Access Compliance Report

Public Rights-of-Way

Intersection ID: 13749	Main Street: BARRINGER_DR	Cross Street: REMOUNT_RD	Location: NE
ADA ID: BE0D595B98EA	Ramp Type: Perp	Initial Pass/Fail: Fail	Overall Compliance: No
Severity Score: 31.25			
Codes/Mitigation Info/Possible Solution		Field Measurements/Component Compliance

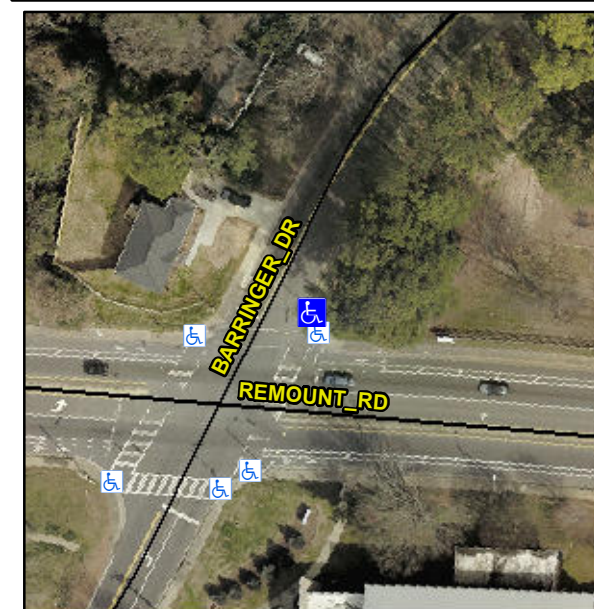
**Remove & Replace Entire Ramp.
Restripe Crosswalk.**

R304.5.1, R304.2.2, R304.5.3
